Revised Sections

The following text is proposed to be added to Article 10, Section 15-1004-C-1:

FIGURE 15-1104-F.2: SIDEWALK CONNECTIONS

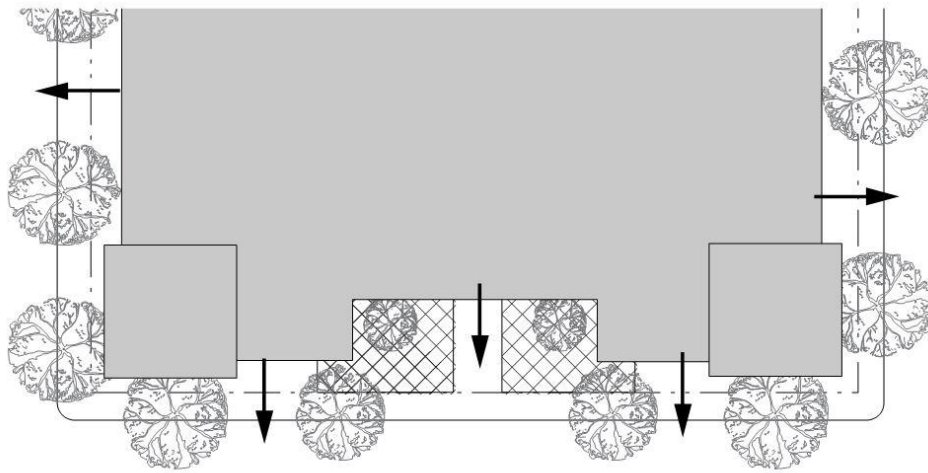
- a. *Common Area Sidewalk Connections.* Common entrances into lobbies or internal pedestrian paths shall be provided at a rate of no less than one per 400 feet of linear street frontage. When providing access to a structure, such entrances shall be protected by a portico, canopy, or alcove of no less than four feet in depth. When providing access to a structure such entrances shall also feature an architectural element which clearly distinguishes them from entrances into individual dwellings.

- b. *Residential Unit Sidewalk Connections.* Direct entrances into individual ground-floor dwelling units which are adjacent to streets shall be provided at a rate of no less than one per 100 feet of linear street frontage. Such entrances shall be protected by a portico, canopy, or alcove of no less than four feet in depth.

- c. *Commercial Sidewalk Connections.* Direct entrances into ground-floor commercial establishments which are adjacent to streets shall be provided at a rate of no less than one per 100 feet of linear street frontage. When establishments with dimensions greater than 100 feet occupy a site, they shall be set back and wrapped with smaller spaces that will satisfy this requirement. See Figure 15-1104-F.2.c.

FIGURE 15-1105-B.2: BUILDING HEIGHT ARTICULATION

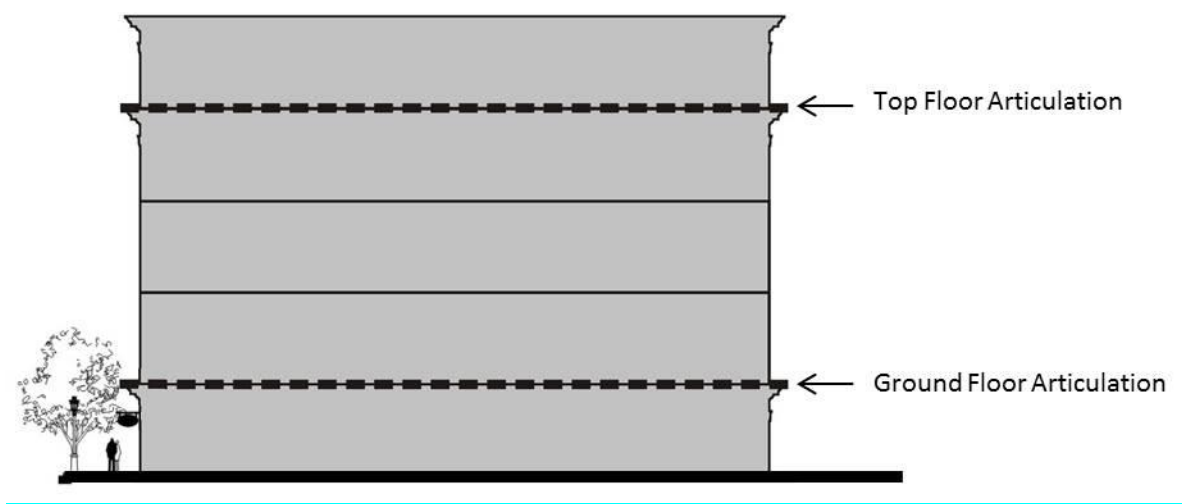
2. **Building Height Articulation.** In order to maintain a human scale for multi-story buildings, the height of façades shall be broken into smaller increments as follows:

- a. Ground Floor. A substantial horizontal articulation of the façade shall be applied at the top of the first story. This element shall be no less than 18 inches tall, and should project from the adjacent wall plane. It shall be designed as a cornice, belt course, or a similar architectural element which is appropriate to the style of the building.

- b. Top Floor. Buildings or portions of buildings which are four stories in height or taller shall also provide articulation for the top story of the building. This may be accomplished by a color change, material change, a cornice/belt course at the bottom of the uppermost story, by stepping the uppermost story back, or similar measures.

FIGURE 15-1105-D.2: GROUND FLOOR COMMERCIALTRANSPARENCY

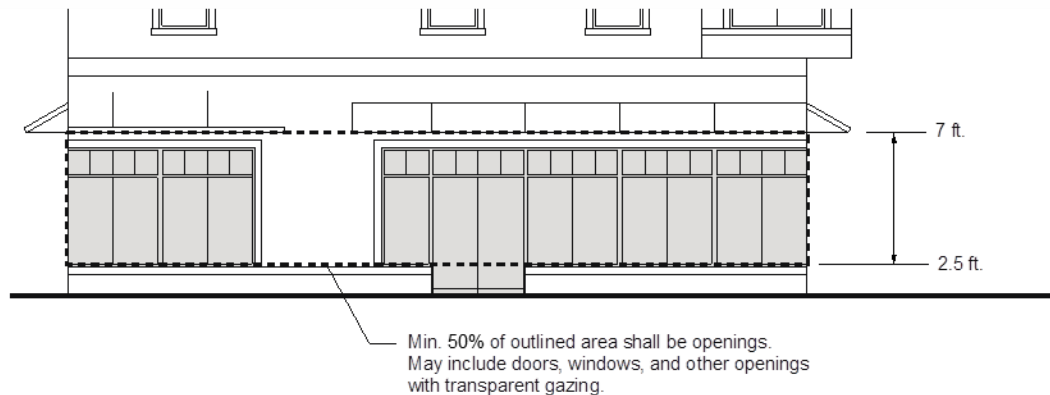
2. **Ground Floor Commercial Transparency.** For ground floor street-facing façades on portions of a structure occupied by commercial uses, exterior walls facing a front or street-side lot line shall include windows, doors, or other openings with transparent glazing for at least 50 percent of the building wall area located between 2.5 and seven feet above the level of the sidewalk. Openings fulfilling this requirement shall have transparent glazing and provide views into work areas, display areas, sales areas, lobbies, or similar active spaces, or into window displays that are at least two feet deep. The Review Authority may waive or reduce this requirement if doing so is necessary to satisfy State or local energy efficiency requirements.
